## ST. TAMMANY PARISH

**Addendum No.:**4

**Bid#:** 24-62-2

**Project Name:** Cross Gates Wastewater Treatment Plant Improvements

SHEET NO.  
3S-5

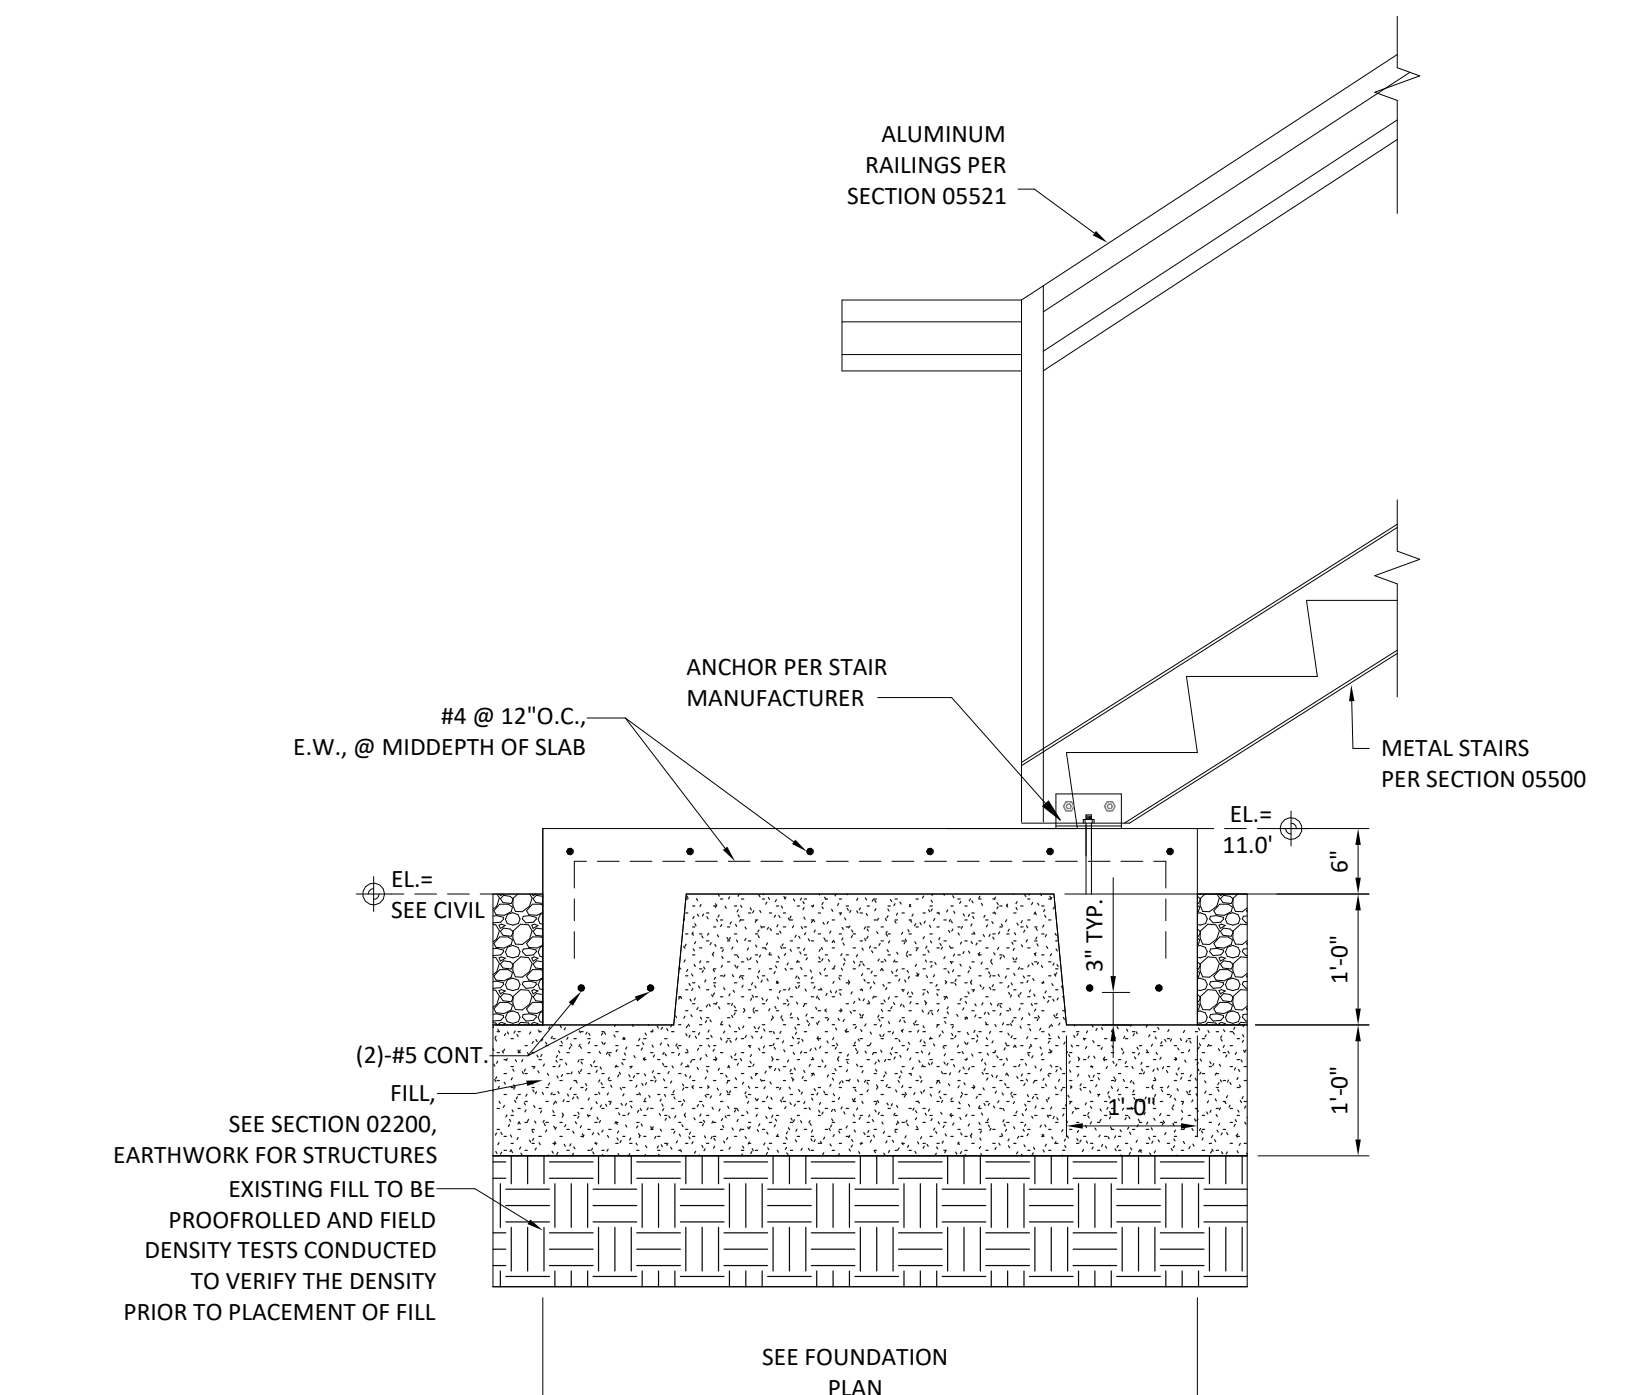
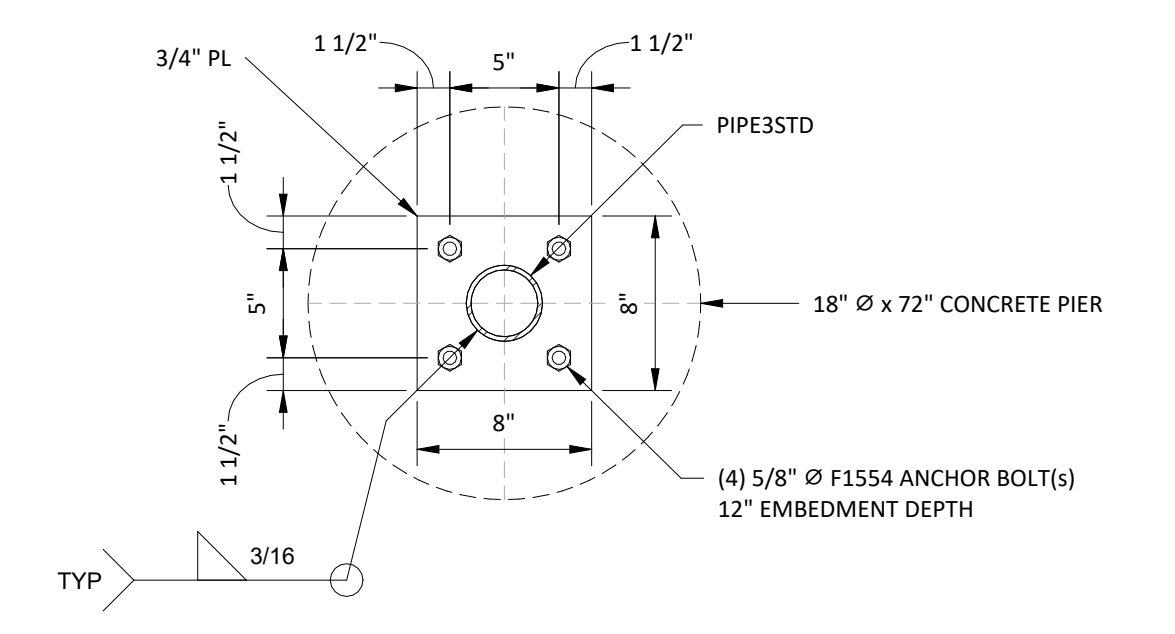
QUESTION 2: Do not see details on the staircase for the UV Basin. What are they made of?

ANSWER 2: Details have been added to Sheet 3S-5.
